**Record of Decision**  
**William Benson Landfill Site**  
**Livonia (T) Livingston County**  
**Site Number 8-26-007**

## **DECLARATION STATEMENT - RECORD OF DECISION**

### **William Benson Landfill Inactive Hazardous Waste Site Livonia (T), Livingston County, New York Site No. 8-26-007**

**Table 4  
Remedial Alternative Costs**

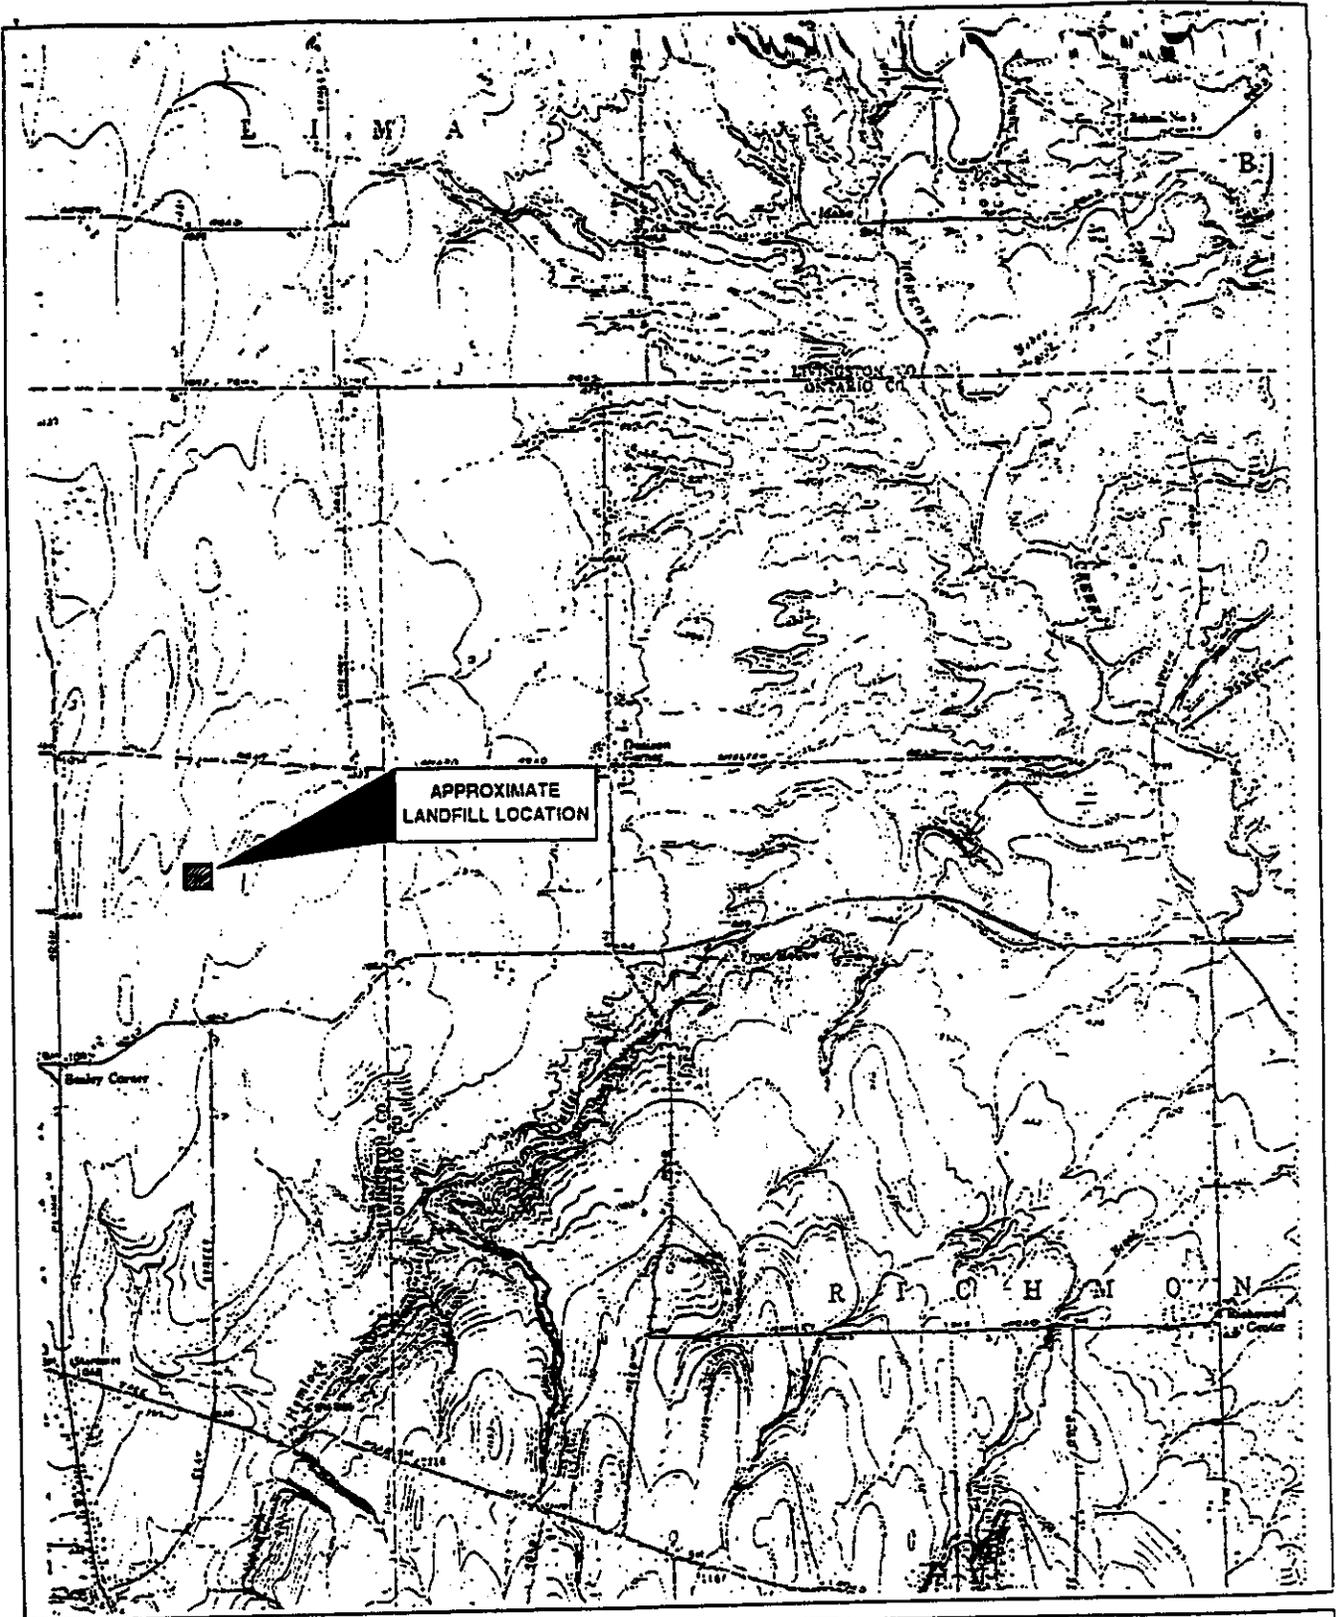
**COMMENT 27:** Is the cost for the cleanup just the subcontracting work or does that include monitoring costs? How much will construction cost? What are the other costs?

**COMMENT 35:** The cost estimate summary for Alternative 4 (Modified 6 NYCRR Part 360 Cover System) in the Summary of Evaluation Alternatives (PRAP p.15) is inconsistent with the cost estimate for Alternative 4 in the Summary of Proposed Remedy (PRAP p. 18-19). The present worth in the Summary of Evaluation Alternatives is \$2,382,000, while the present worth in the Summary of Proposed Remedy is \$2,274,000. The capital cost in the Summary of Evaluation Alternatives is \$1,794,000 while the capital cost in the Summary of Proposed Remedy is \$1,517,000. The higher present worth and capital cost are consistent with the FFS (FFS Table 4-3(b)).

**COMMENT 40:** The cost estimates for the proposed remedy in the PRAP are inconsistent (e.g. total cost is estimated at \$2,382,000 on page 15 and in Table 2 on page 21, but is estimated at \$2,274,000 on page 19).

**RESPONSE 27:** The costs included in the PRAP and now in the ROD represent an estimate of the costs not only to construct the remedy (the capital cost) but also address the operation and monitoring costs (the annual cost). The combination of these costs is the present worth cost which is a calculation which presents both the capital and annual operating cost, in terms of their present value, to allow a comparison of the various alternatives to be made. These costs are presented for each of the alternatives evaluated in Table 4 of the ROD.

**RESPONSE 35:** The correct costs were presented at the public meeting and are included in Table 4 of the ROD.

**RESPONSE 40:** The correct costs were presented at the public meeting and are included in Table 4 of the ROD.
